Instruction Sheet for Ice Maker Control Board

NOTE: Due to a quality improvement this control board will replace the older designs.

Run Sequence Chart for old Control Board 6100499

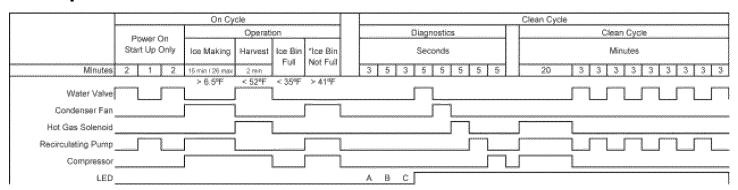
- The ice making cycle has a 15 minute minimum and 25 minute maximum time limit. This eliminates the production of ice slabs being too thin or too thick.
- During a harvest, the water valve "on time" is now limited to 1 minute to reduce water usage. This also eliminates the condition of the water valve being energized for an unlimited amount of time if the evaporator thermistor is not located correctly or the reversing valve has failed or is unplugged. If the evaporator thermistor is unplugged, a default 25-minute freeze and 4-minute harvest interval will occur.

If the unit stays in harvest mode for more than 16 minutes the unit will go into a failure mode, shutting the unit down and flashing the LED light. To get out of failure mode. Shut the unit off and then back on again. This will reset the control board. If the failure was not corrected the unit will return to failure mode when the unit reaches it's 16-minute cycle again. If this occurs find the cause of the failure and repair it, then unplug the unit to reset the board.

- The diagnostic mode sequence was changed, moving the bin and evaporator thermistor checks to the beginning of the sequence. The old boards had these checks at the end of the sequence.
- Whenever the unit has reached a failure mode, the LED will flash and the product will shut down. If the failure was caused during a harvest cycle which lasted more than 16 minutes, the LED will remain flashing on and off in half second increments. If the failure is caused by a faulty bin thermistor (not detected), the LED will remain flashing on and off in one second increments. These are the only two failures that cause the unit to reach a shut down failure mode.

- During the clean cycle, the control board performs the diagnostics first. If the bin thermistor is not detected, the LED will flash on two times. This is followed by a 3-second delay. If the evaporator thermistor is not detected, the LED will flash on 5 times. This will be followed by a 3 second delay. The LED will then come back on and remain illuminated for the remainder of the clean cycle and until the unit is turned back on. A check can be done on the board and thermistors, unplug either thermistor electrical connection and then press the clean switch. The LED should flash as described above, depending upon which thermistor is unplugged or if both are unplugged.

- The 30-seconds of refrigerant only at the beginning of the freeze cycle has been removed. Now the refrigerant and the recirculating water will start at the same time. This will reduce the number of slabs that get stuck half-way off of the evaporator by not allowing them to refreeze to the evaporator plate.

- A minimum harvest time of 2-minutes now occurs at the beginning of the harvest cycle before the evaporator thermistor is used to determine if a slab has released from the plate.
